BROWNS FERRY NUCLEAR PLANT (BFN) – UNITS 1, 2, AND 3 - TECHNICAL SPECIFICATIONS (TS) CHANGES TS-431 AND TS-418 – EXTENDED POWER UPRATE (EPU) – RESPONSE TO ROUND 19 REQUEST FOR ADDITIONAL INFORMATION (RAI) (TAC NOS. MD5262, MD5263, AND MD5264)

TENNESSEE VALLEY AUTHORITY
BROWNS FERRY NUCLEAR PLANT (BFN)
UNITS 1, 2, AND 3

RESPONSE TO ROUND 19 REQUEST FOR ADDITIONAL INFORMATION (RAI)

Figure EMCB.189-2: Drain Channel Stress Profile Comparison

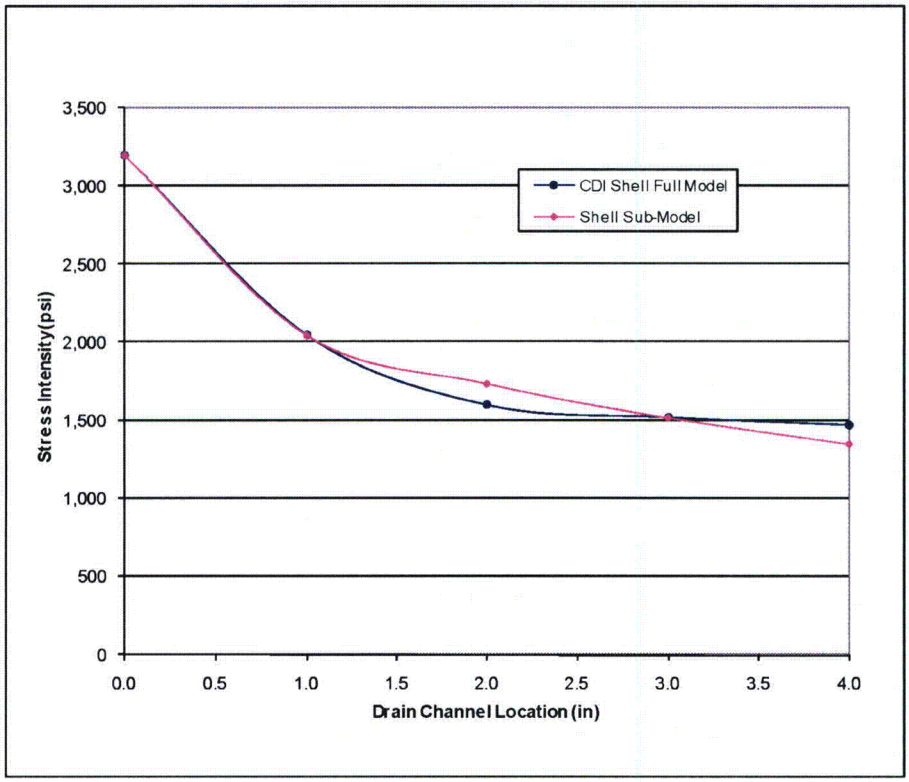
Provide the final magnitude of imposed displacement along with the location and a comparison of the resulting sub-model stress profile and the full model stress profile.

The stress profile comparison is focused on the 5 nodes closest to the location of interest, which is located at the bottom of the drain channel (i.e., at 0 inch vertical location). Nodes further away from the location of interest have diminished and have insignificant influence. It is considered that the stress profile comparison up to the first 5 nodes is sufficient.

Figure EMCB.192/150-1: Illustration of Typical Placement of ASBs

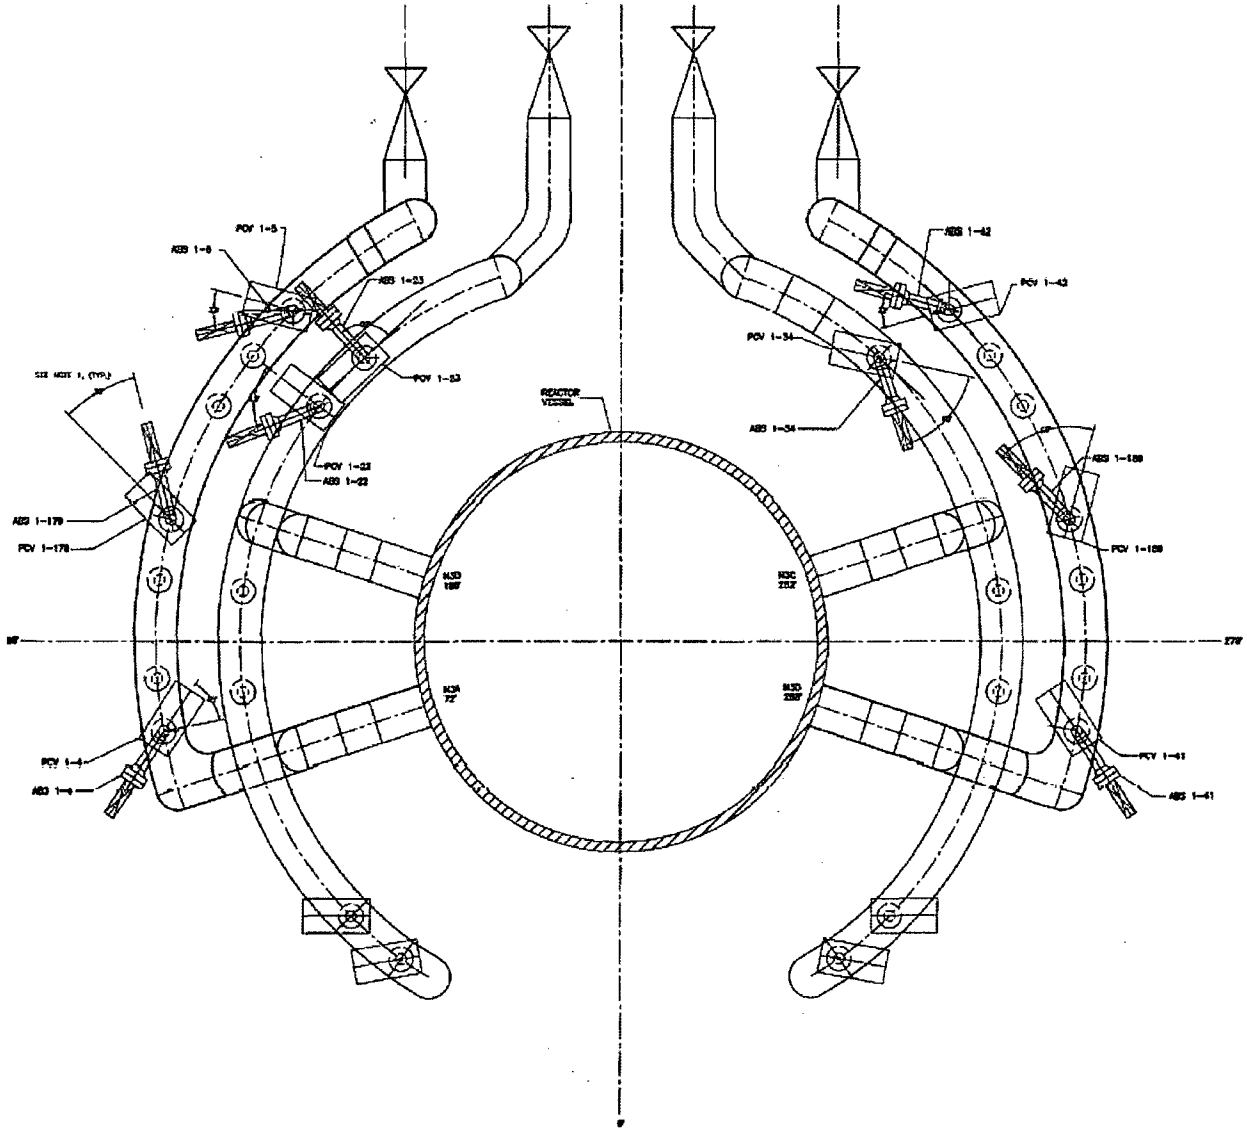
Provide the following information about the planned acoustic side branches (ASBs) for Units 1 and 2, including validation results:

(a) ASBs will be installed on the nine SRVs that are in the main steam flow path. Four SRVs are located on the MSL dead legs and will not be modified with ASBs. Figure EMCB.192/150-1 shows a typical placement of ASBs for BFN. This is a preliminary drawing and final orientation of the ASBs on each unit may vary.

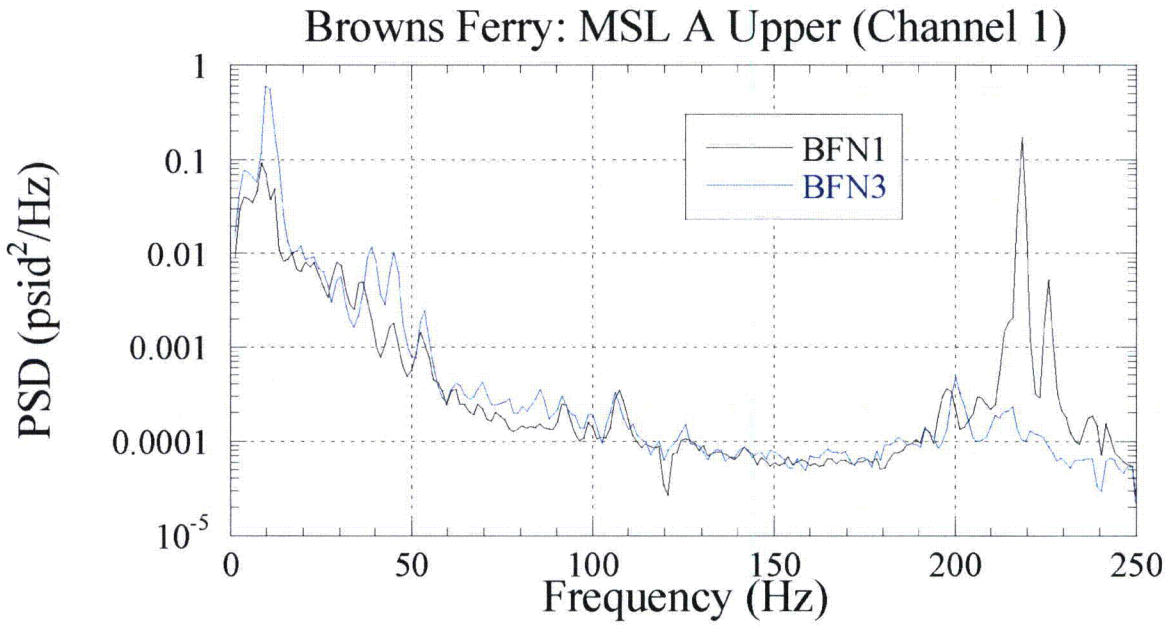
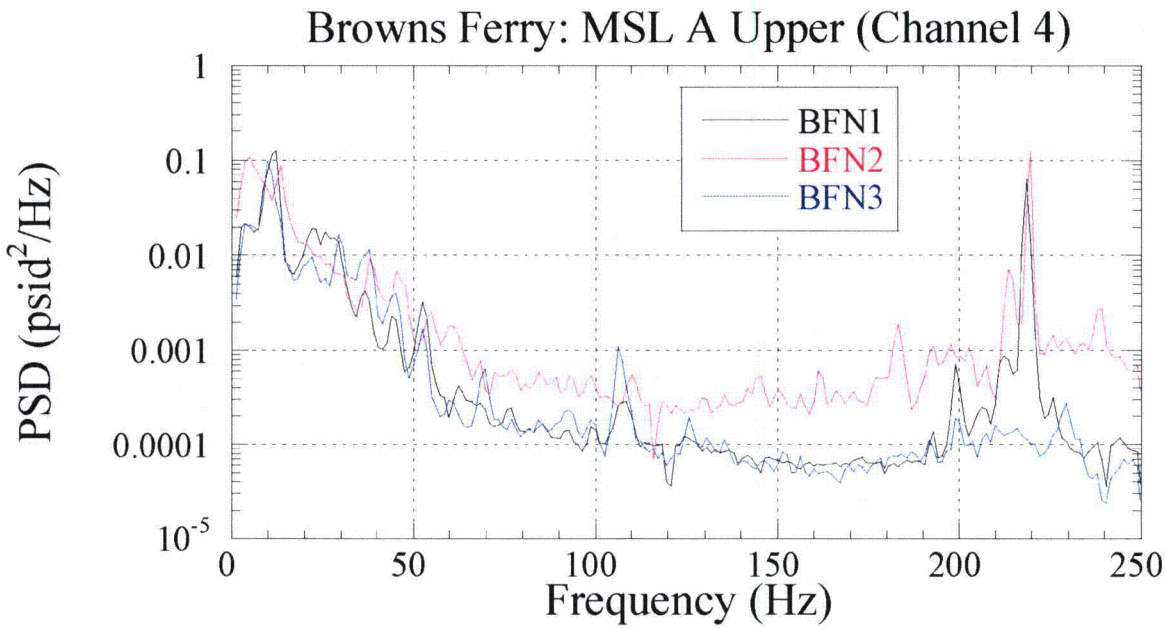
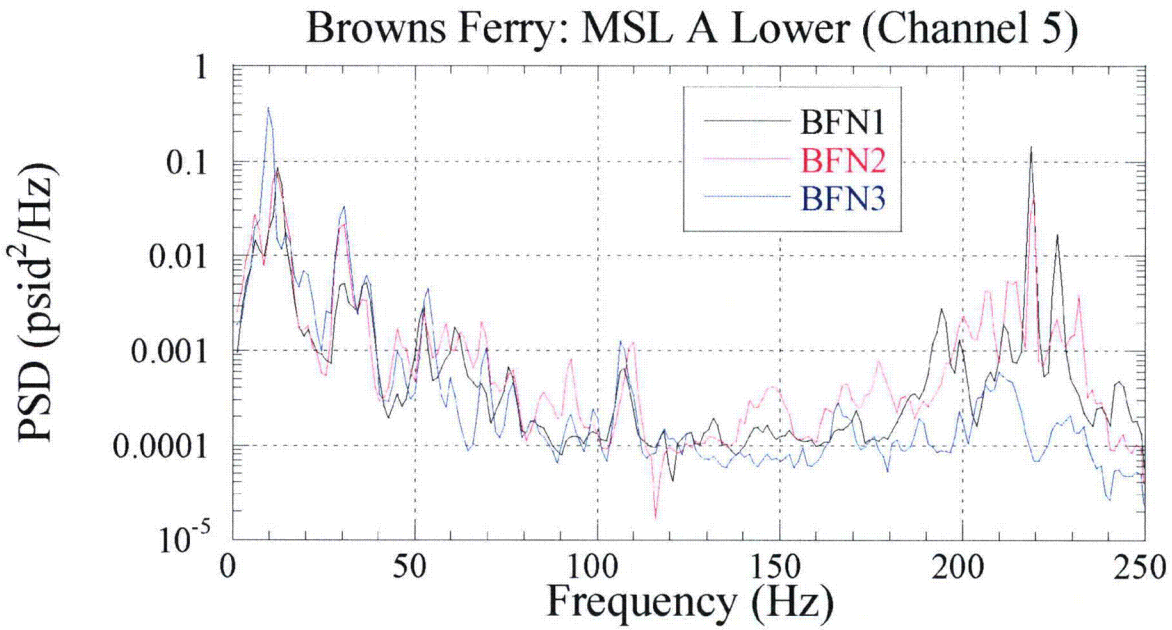
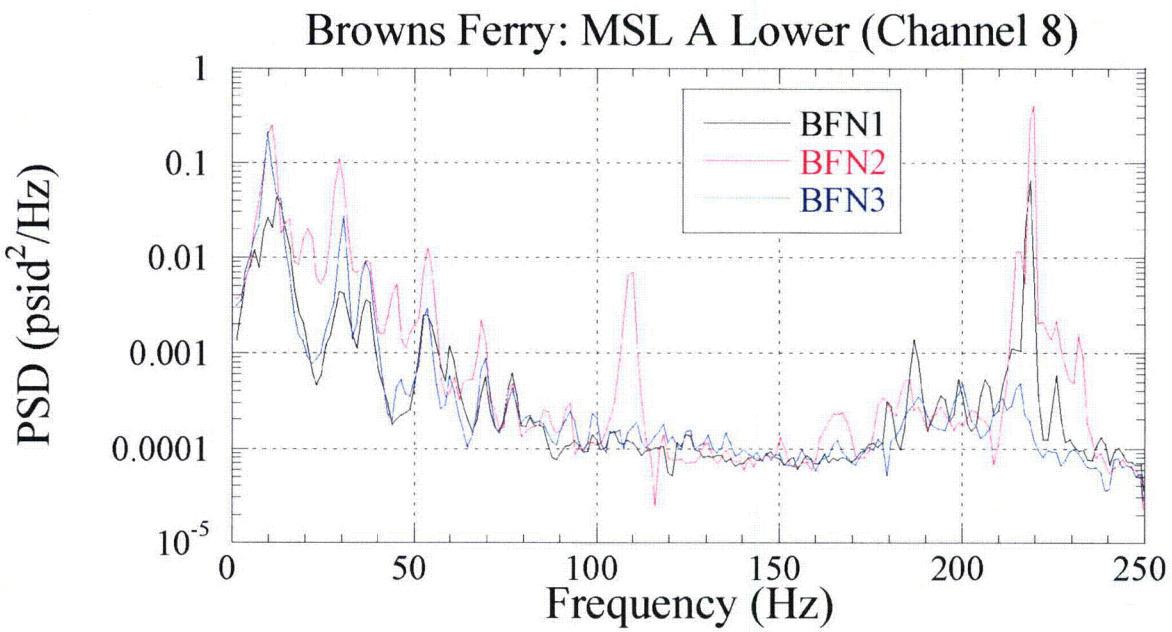
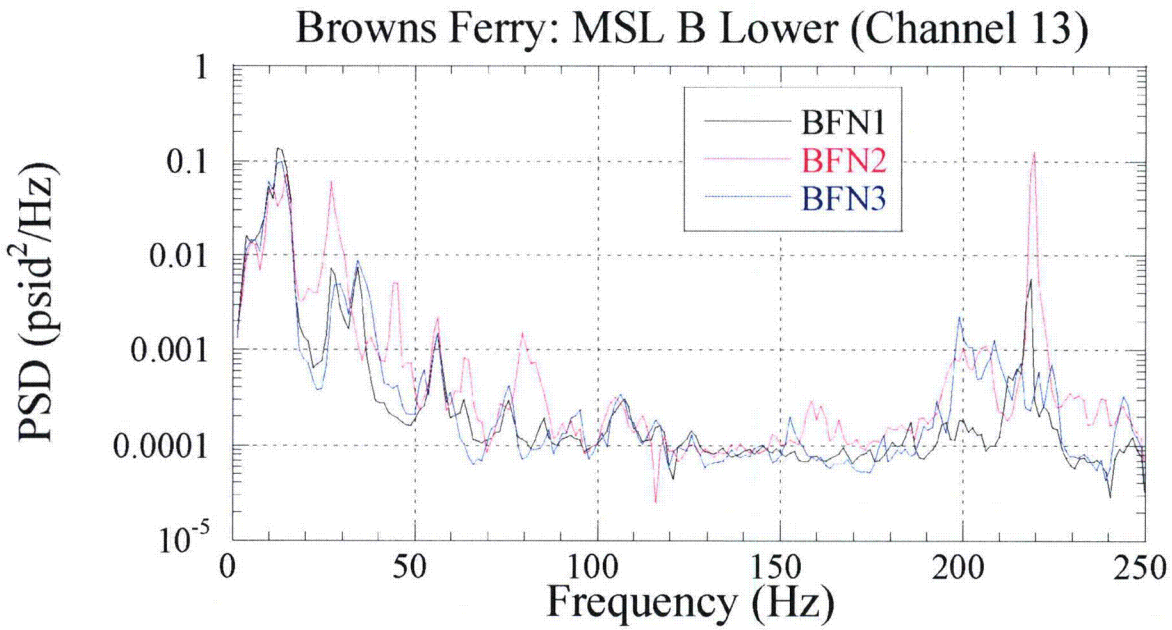
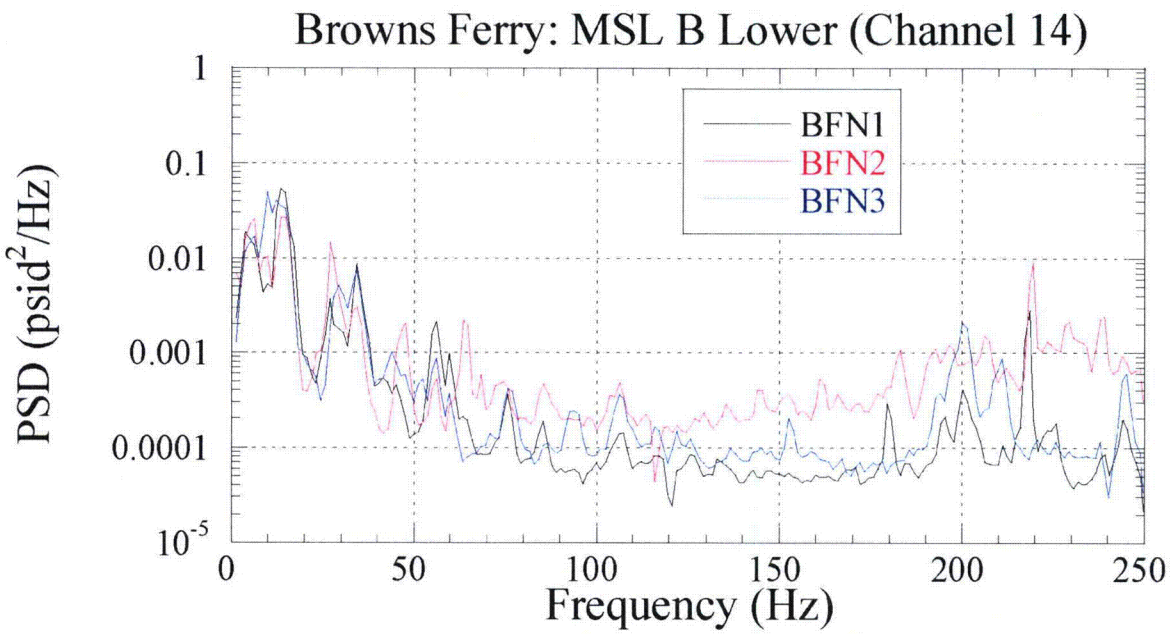
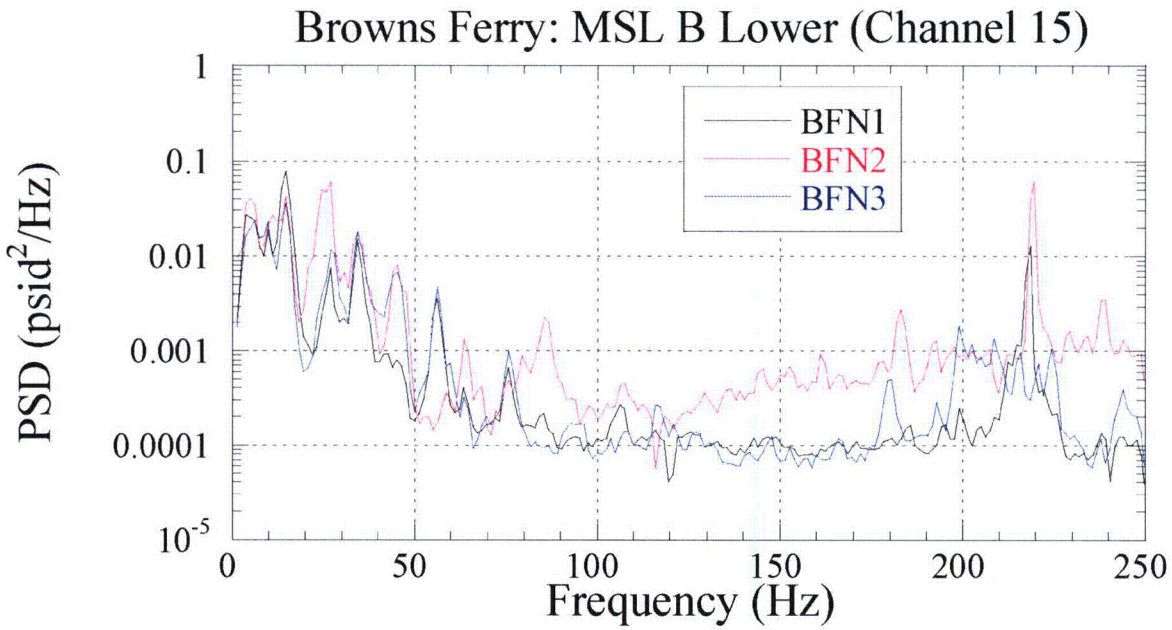
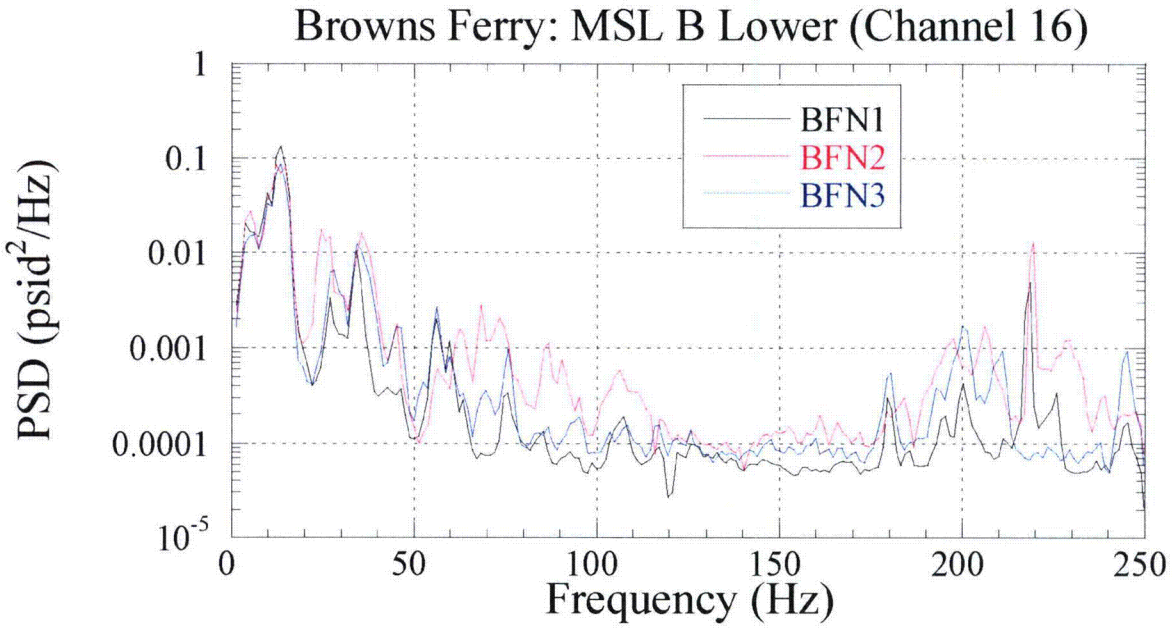
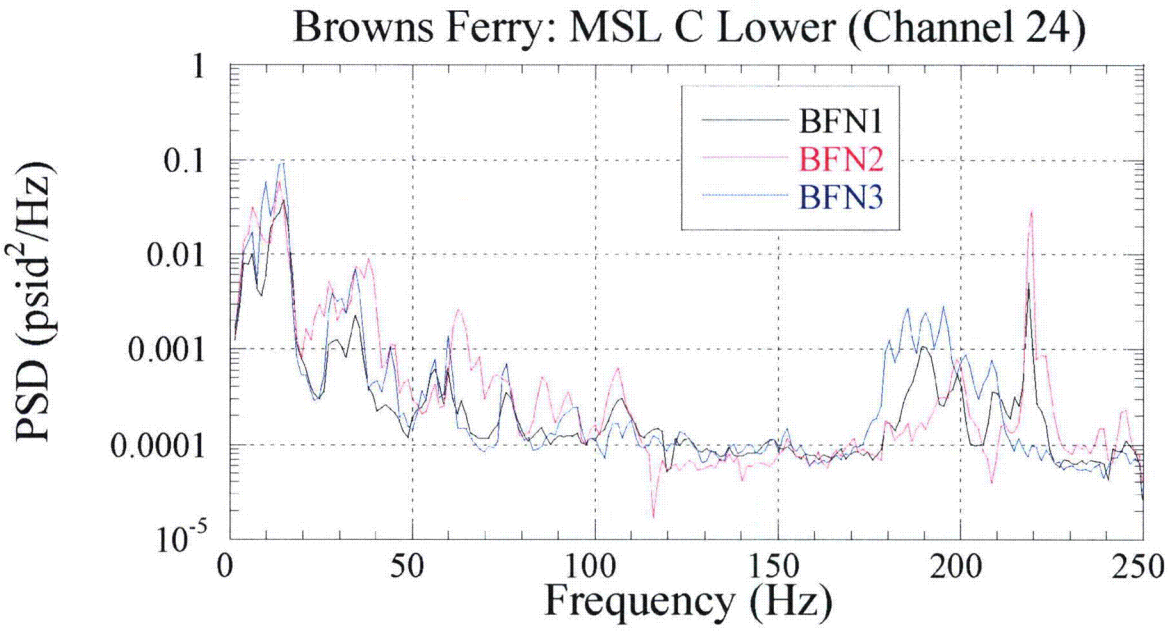
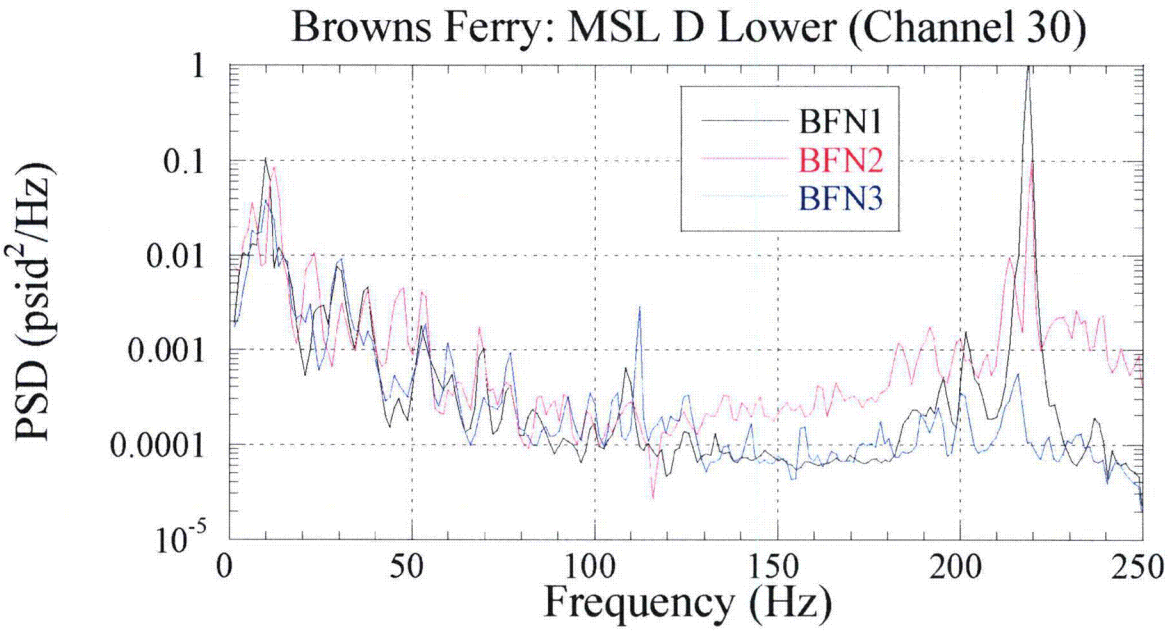
In the response to RAI EMCB.130/97, TVA provides a comparison between the Unit 3 MSL strain gage signals (with acoustic vibration suppressor(AVS)) with the corresponding Unit 1 signals (without AVS), which demonstrate the effectiveness of AVS in suppressing 218 Hz signal. Provide a similar comparison between Unit 3 and Unit 2 MSL signals so that the staff can further evaluate the effectiveness of AVS.

The figures provided in the response to RAI EMCB.130/97 in the June 16, 2008 submittal have been updated with information from Unit 2 in Figures EMCB.151-1 through 5. In these figures, data from the Unit 3 single strain gages at 100 percent power with AVSs installed are compared with data from Unit 1 and Unit 2 single strain gages at 100 percent power at equivalent locations with no AVSs installed. In cases where the Unit 1 or Unit 2 strain gage at the same location was inoperable, the diametrically opposite strain gage was used for comparison. In Channel 1, data was not available for Unit 2. Line noise and reactor recirculation system frequencies were filtered. The 218 Hz signal was not filtered on any unit.
